<p>Submission to: Planning Services Department of Planning and Environment GPO Box 39, Sydney, NSW 2001</p>	<p>Name: ANTHONY OSBORNE</p> <p>Signature: <i>Anthony Osborne</i></p> <p>Please <b>include / delete (cross out or circle)</b> my personal information when publishing this submission to your website.</p> <p><b>Declaration:</b> I <b>HAVE NOT</b> made any reportable political donations in the late 2 years.</p>
<p>Attention: Director – Transport Assessments</p>	<p>Address: 12 SPRING ST BIRCHGROVE</p>
<p>Application Number: SSI 7485 Application Name: WestConnex M4-M5 Link</p>	<p>Suburb: Postcode: 2041</p>

**From:** Anthony Osborne <campaigns@good.do>  
**Sent:** Saturday, 14 October 2017 4:30 PM  
**To:** DPE CSE Information Planning Mailbox  
**Subject:** Submission to WestConnex New M4/M5 EIS, project number SSI 16\_7485

## SUBMISSION OF OBJECTION TO WESTCONNEX M4/M5 LINK EIS.

The EIS states in 6.5.8 Darley Road civil and tunnel site (C4) that:

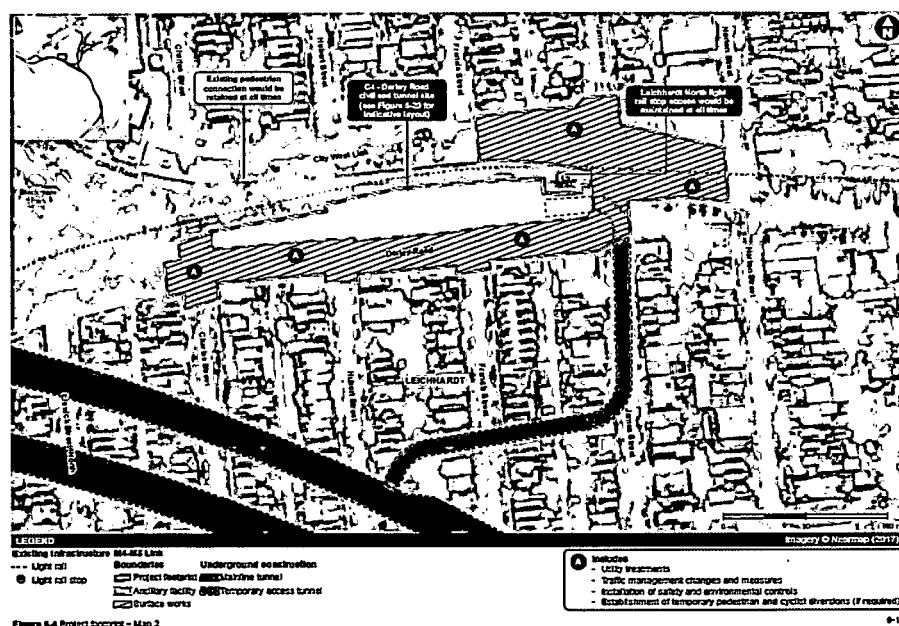
- I object to the EIS because it fails to describe the temporary changes to Darley Road, Leichhardt to enable access to and from the ancillary facility that would likely be required in relation to the Darley Rd site and instead allows for the final plan to be decided by the contractor.

It is not clear how continued access, pedestrian and cyclist movement will be preserved and I am concerned that the impacts have not been correctly identified and assessed by the proponent.

Figure 6-4 Project footprint - Map 2

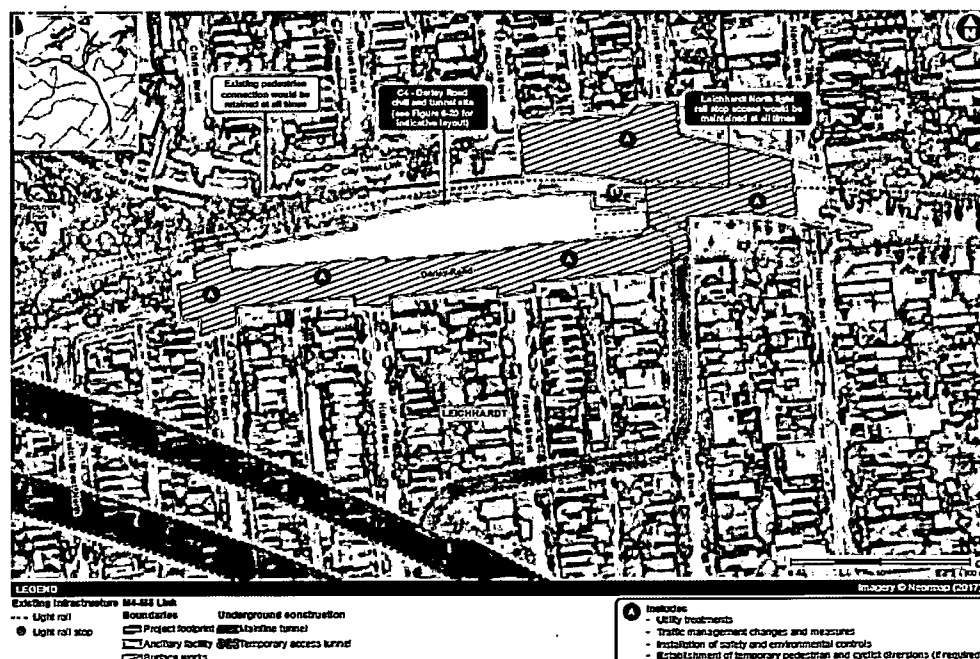
- I object to the EIS because it does not guarantee that the existing access to the Leichhardt North light rail stop would be maintained at all times. Fig 6-4 indicates that only the eastern access will be maintained. This greatly disadvantages the elderly and disabled who have to walk up a steep hill to the eastern access. If the proponent cannot guarantee access to the Leichhardt North light rail stop from the existing entry points or from points that are accessible to all then the Darley Road, Leichhardt construction site should be abandoned. The proponent should be directed to find a site where its operations will not impact on users of the Light Rail.
